**Planning Board Meeting Agenda
Brunswick Town Hall
85 Union Street – Council Chambers
Tuesday, February 10, 2026 @ 6:00 PM**

DRAFT FINDINGS OF FACT SITE PLAN AMENDMENT PLANNING BOARD

MAINEHEALTH
MID COAST CANCER CENTER RENOVATION
81 Medical Center Drive
Brunswick, ME 04011

6 PHARM WEST
A4.01 3/16" = 1'-0"

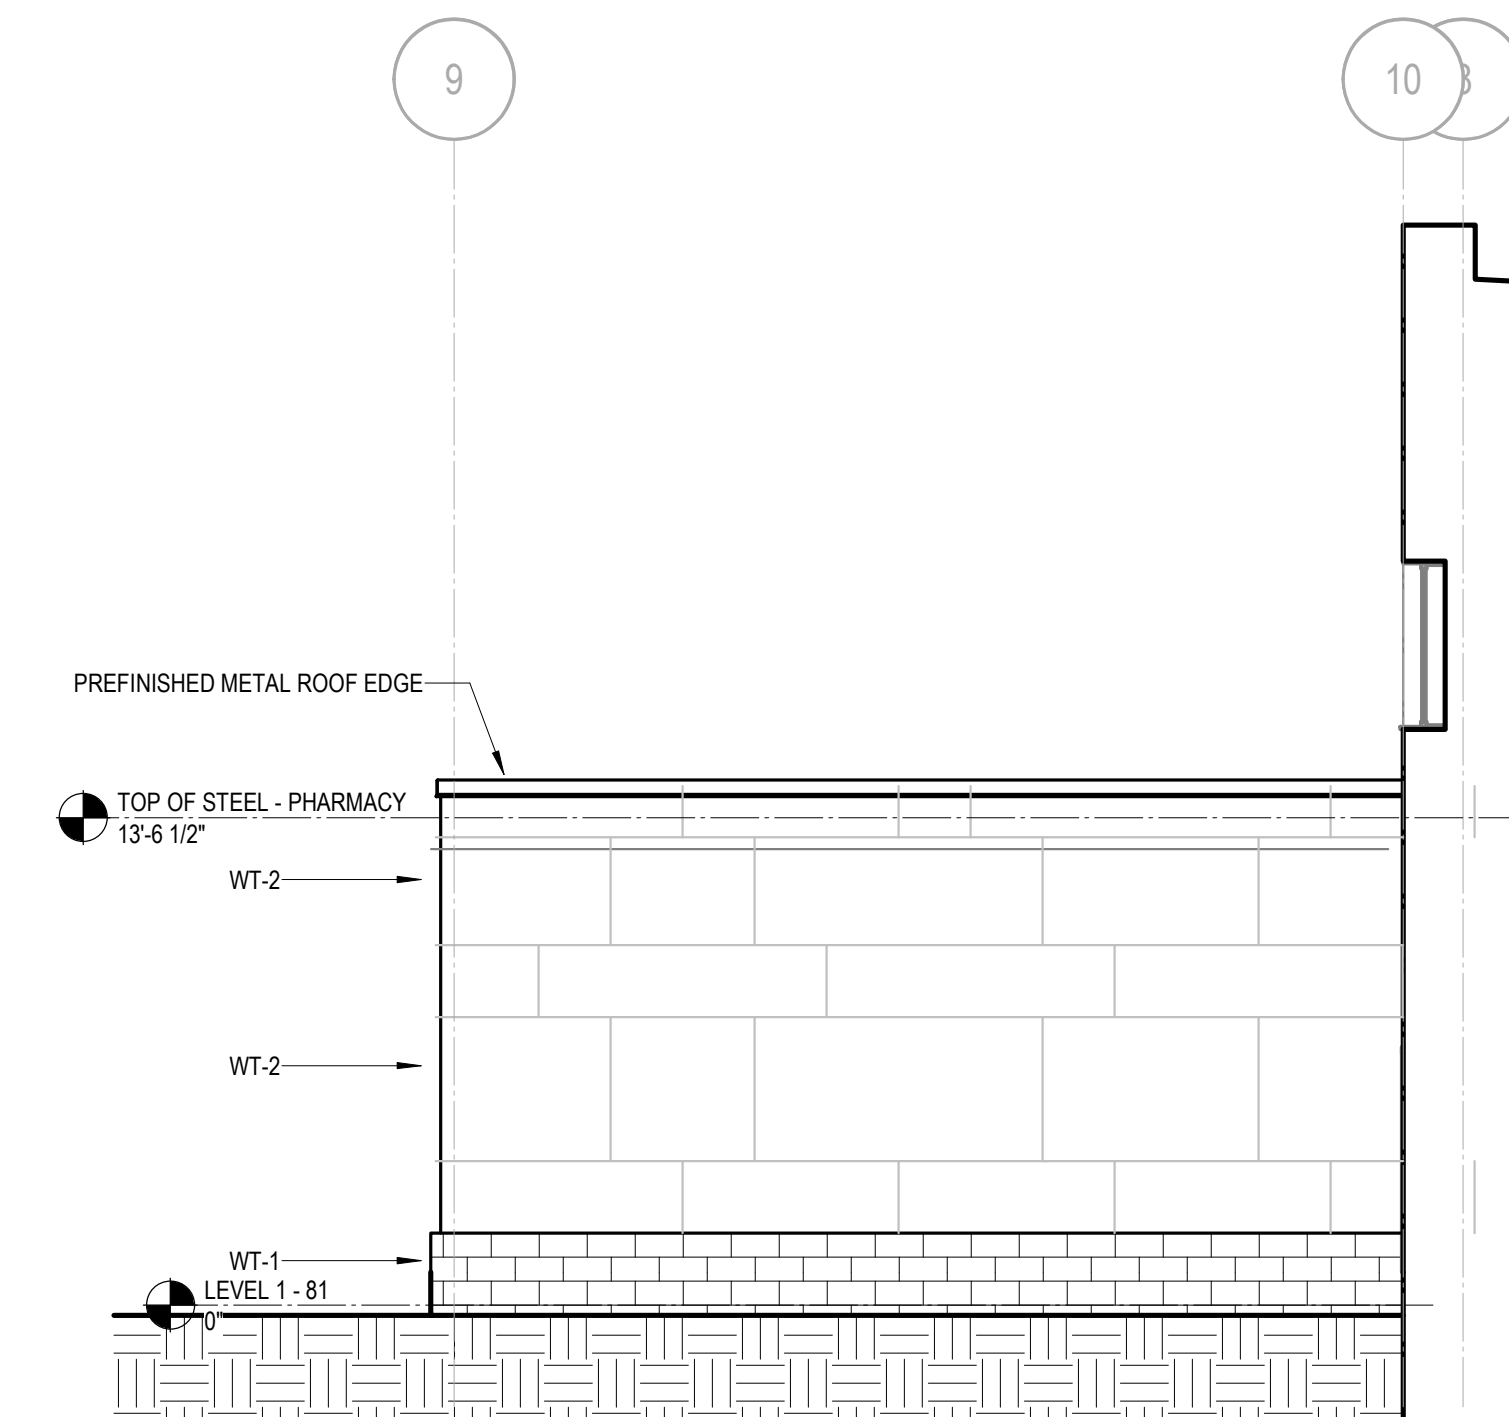
3.4 J Windowless circumstances says, "buildings without windows, i.e. a computer, a server building or self-storage buildings, shall incorporate a change in scale and siding materials instead of windows to create a sense of rhythm and cadence to create human scale. These material scale changes shall be demonstrably compatible with the scale and cadence of adjacent building facade treatments". The LINAC part of the building is towards the back, but the pharmacy faces a parking lot, so that is a little bit human facing.

3. Add ornamental grass along parking lot side of pharmacy, near bollards	See Section B-B on AS3.00 Civil Details
Architecture Comments	
4. Review Cooks Corner Design Standards, specifically Section 3.4 Façade Requirements, and within 3.4.j.	See Exhibit 8: Cook's Corner Design Standards Narrative.
Engineering Comments

The two additions to 81 medical center drive are secondary facades according to the definition in Section 3.4 Façade Requirements item C.

SHEET TITLE AND NUMBER:
AS1.00
PROPOSED SITE PLAN

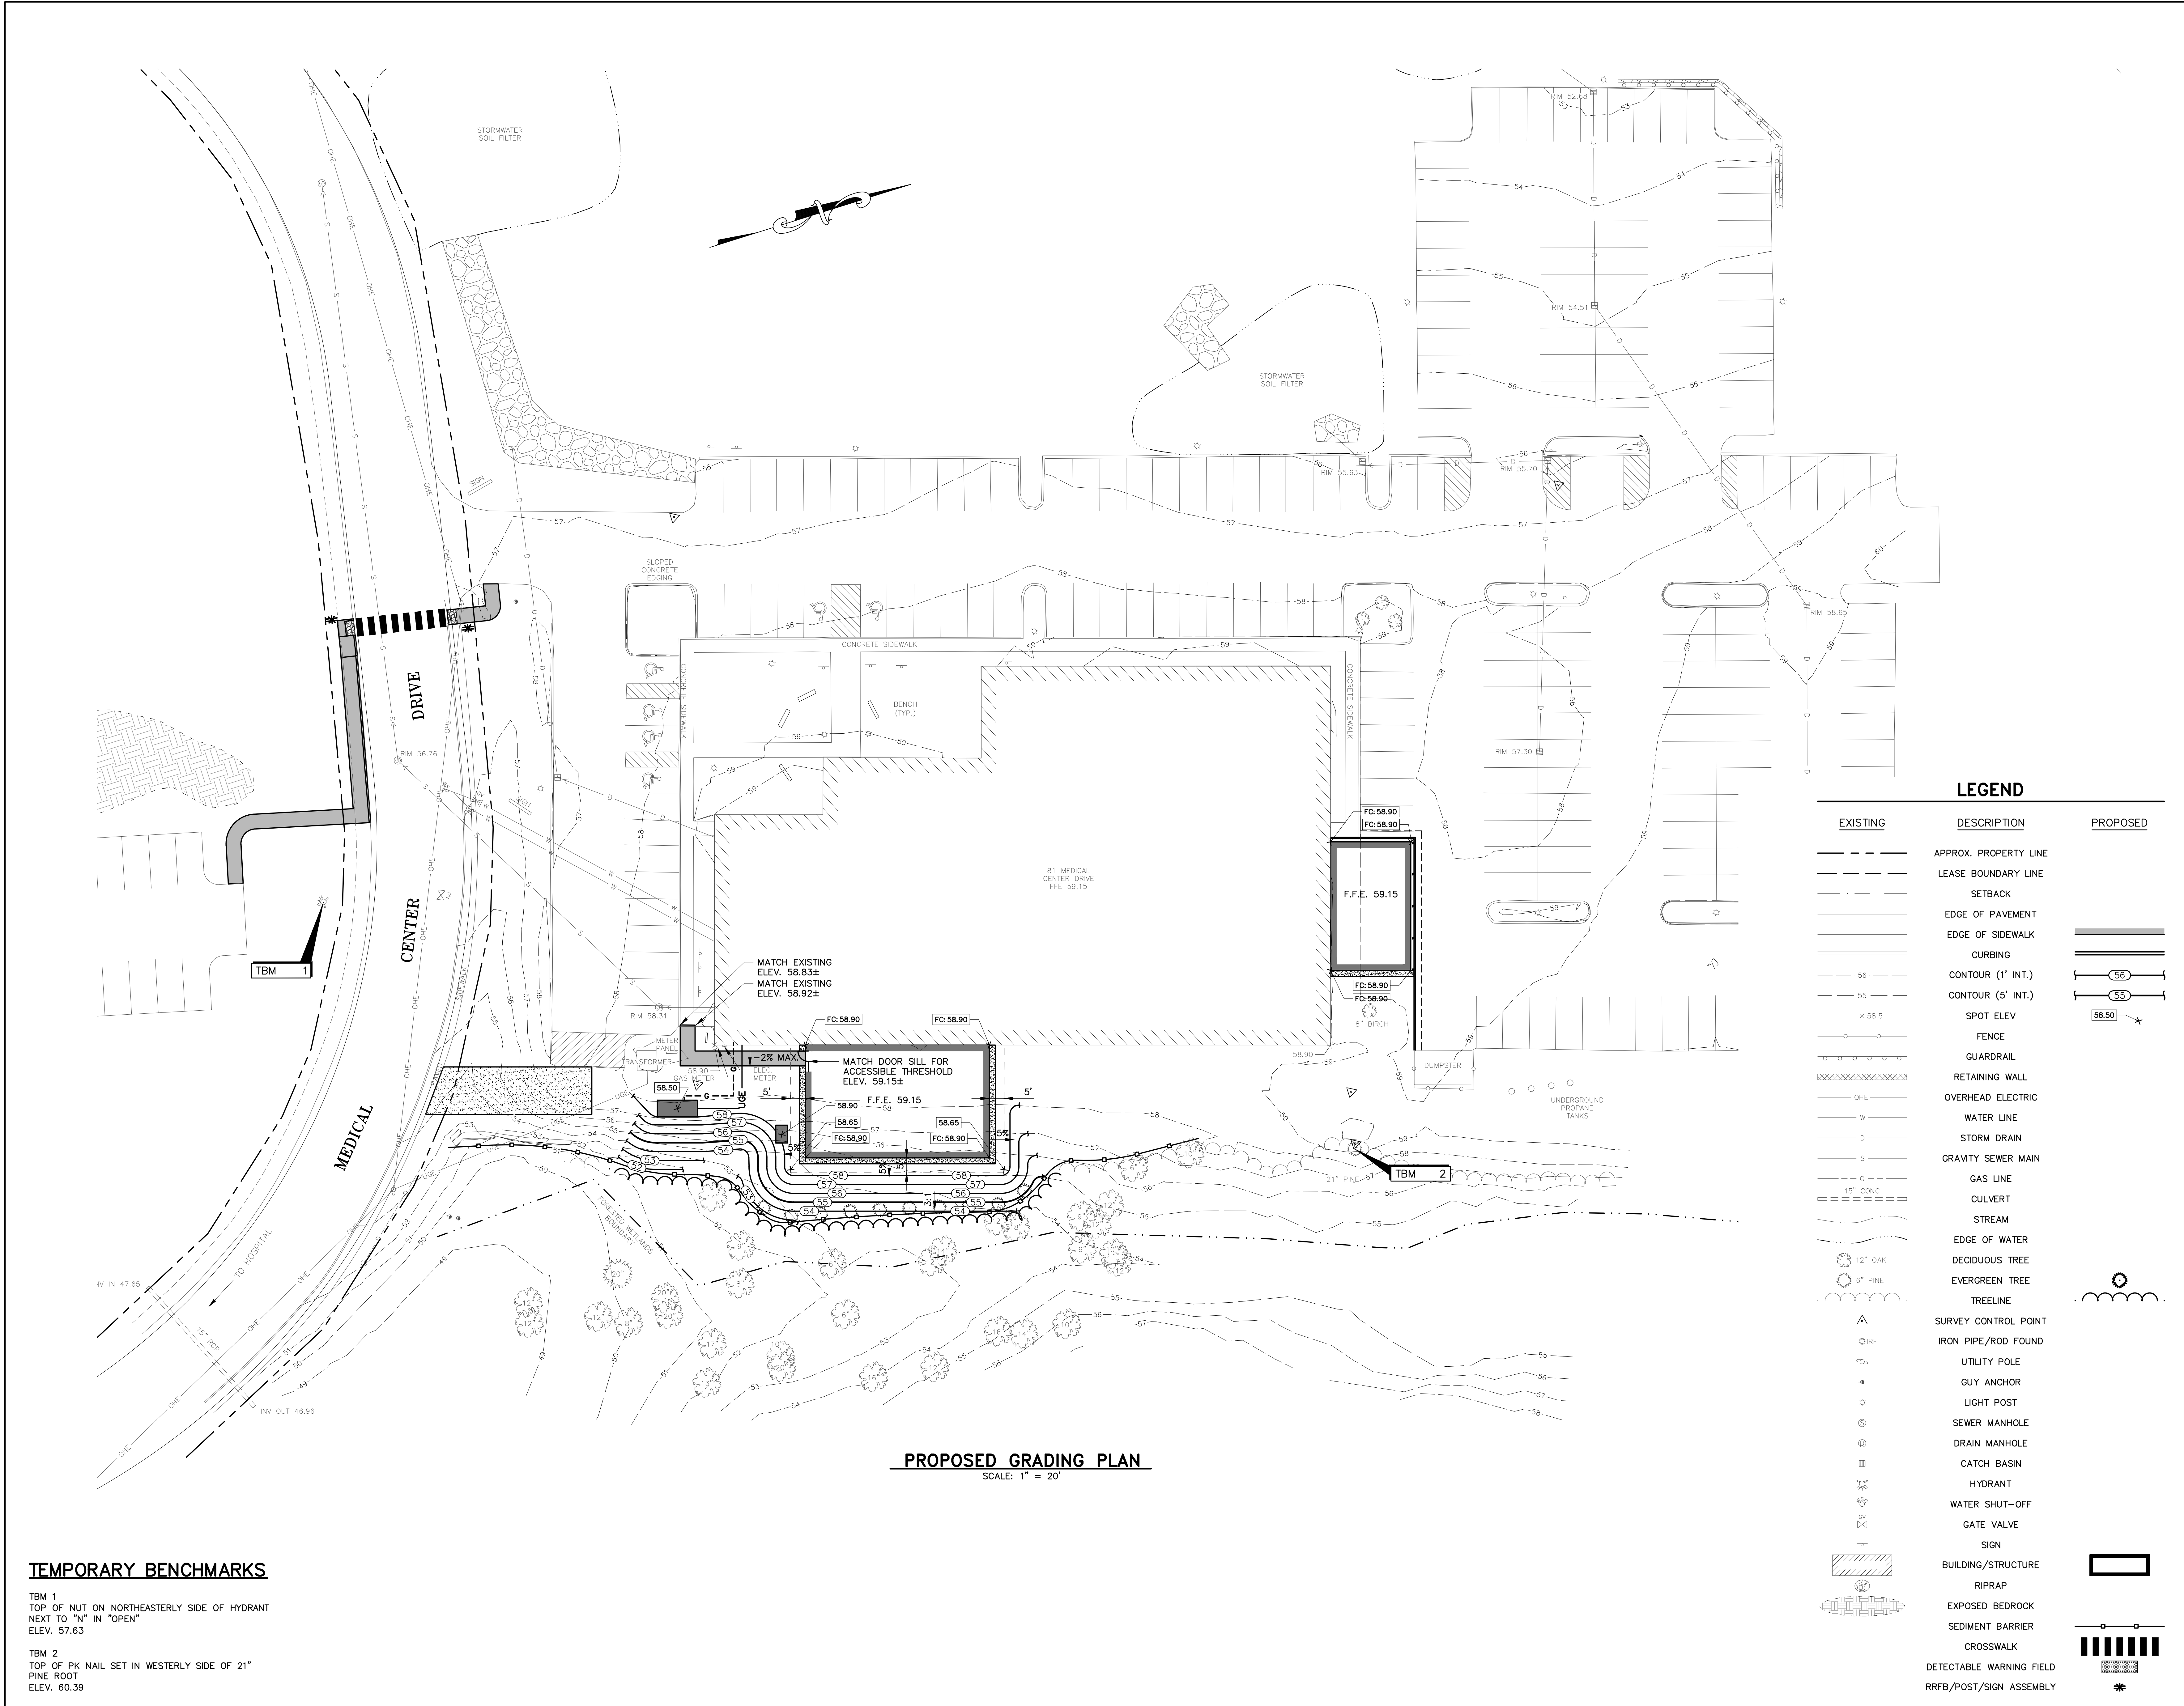
Landscaping Comments	Applicant Response
1. Add 10 evergreen trees at 10' o.c. spacing along proposed treelines	The proposed trees have been added to AS1.00 Proposed Site Plan.

6. Add Erosion Control Barrier linework to plans	Linework for the temporary sediment barrier has been added to AS1.00 Proposed Site Plan.
7. Add bicycle rack locations and callouts to plan (min. 13 spaces)	The proposed bicycle rack has been added to AS1.00 Proposed

Site Plan.
8. Add callouts for sediment sack to inlets	A callout for Temporary inlet protection has been added to AS1.00 Proposed Site Plan
General Comments
